AGENDA
Planning Commission Meeting

A. 0008 Silver Star Trail - New Single Family Residence

Final Plan Review for New Home

Hearing Date:	July 10, 2024
File Name and Process:	Single-Family Residence Final Plan Review
Owner/Applicant:	Russell Frederickson
Representative:	Taylor Hermes & Rick Hermes, Minturn North Construction Company
Legal Description:	Subdivision: MINTURN NORTH PUD Lot: 38
Address:	0008 Silver Star Trail
Zoning:	Game Creek Character Area – Minturn North PUD Zone District
Staff Member:	Madison Harris, Planner I
Recommendation:	**Approval**

File Name: *22036 c-grading.dwg*

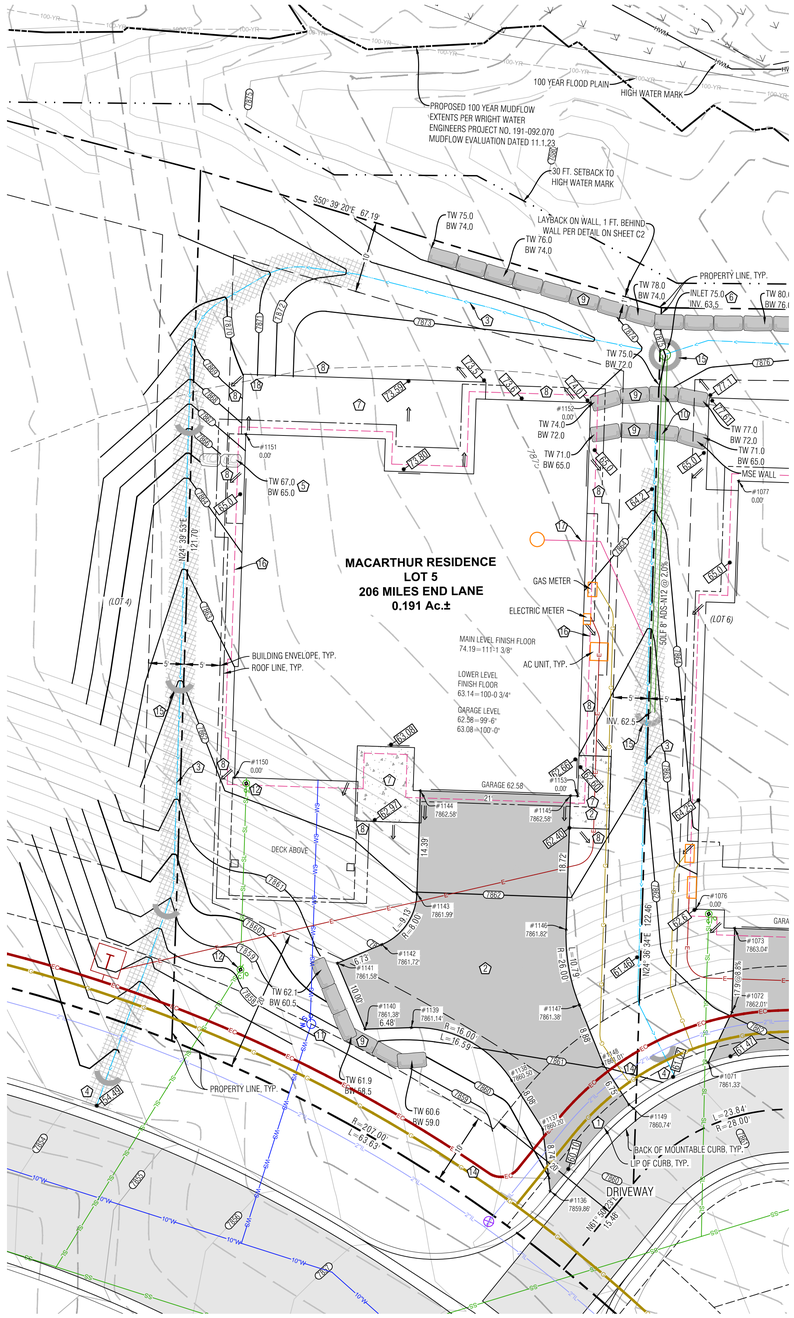
2. Complete. ~~The limits of the Debris Flow mapped in the November 2023 *"North Minturn PUD Mud and Debris Flow Analysis*" prepared by Wright Water Engineers Inc should be shown on the Site Plan.~~
3. The site plan shows a "High Mark." The "Ordinary High Water Mark (OHWM) as defined in section 17-2-10 of the MMC along with required setbacks should be shown on the site plan. The OHWM is shown on Sheet C.7 of *"Minturn North PUD Overall Grading and Drainage Plan; Construction Plan Set 5/1/24"* and the *"Final Plat: Minturn North PUD"* recorded March 4, 2024, referenced above. The OHWM should be labeled on the permit set of plans.
